## Lotis 2 - Residential

## STAFF REPORT

**Petition Number:** 2025-0009-ARB

Architectural Review Board approval of the elevations, architectural details, exterior colors, and materials for the proposed Lennar residential development within the residential pod of the Lotis Wellington 2 mixed-use project.

**SF Model 2016 (Exhibit A)**

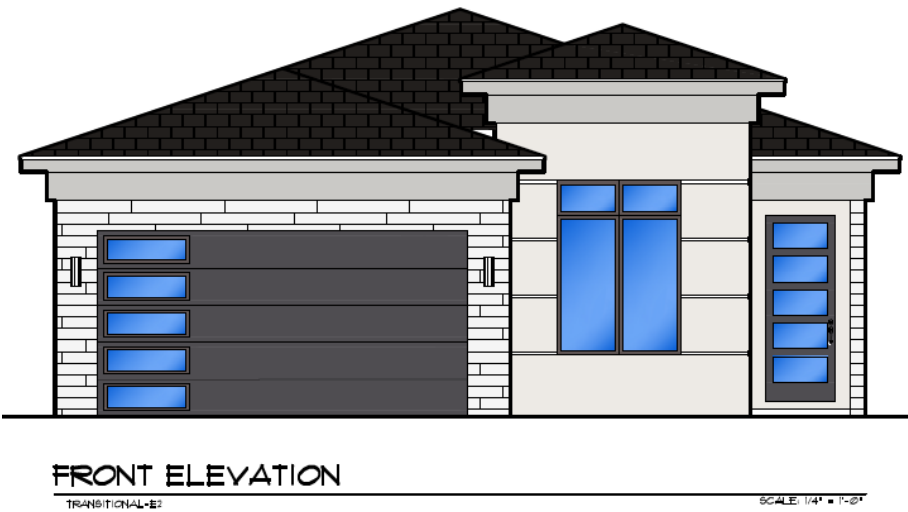
Table 6.4-1 of Wellington’s LDR provides a Design Criteria Point System requiring single-family buildings to meet a minimum of 80 points, unless an alternative design is approved by the ARB, based on various aspects of the proposed architectural design and elements/materials. Below are some illustrations of each of the single-family residential building model types with design chart identifying how the applicant intends to meet each of the design criteria points (Per Table 6.4-1) for each model and elevation options, and the overall total points for each model.

TABLE 6.4-1 TABULATION	
DESIGN CRITERIA	POINTS
2,000 - 2,499 SF UNDER AIR	10
ENTRY FEATURE	10
FIRST FLOOR TIE BEAM 9 FEET OF HIGHER	10
3 OR MORE FRONT ELEVATION PLANES	10
2 CAR OR MORE GARAGE	10
PAVER DRIVEWAY	10
3 OR MORE ROOF PLANES	10
CLAY OR CEMENT ROOF TILES	10
ARCHITECTURAL DETAILS	
BELT BANDING	5
TOTAL	85

FRONT ELEVATION

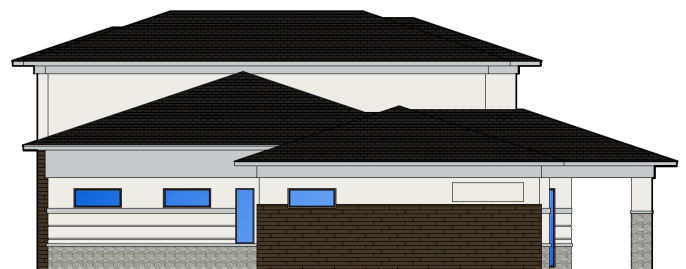
The architectural rendering/elevation drawings of the proposed one (1)-story clubhouse and general office building (Building 3) with a pitched flat tile roof, stucco finish, decorative bands, accent stone cladding, and other architectural details as provided in Exhibit G and illustrated below.

As illustrated above, the building has depth, patterns, and design elements that repeat horizontally and vertically on all façades/elevations, as required for multi-family residential and non-residential buildings.
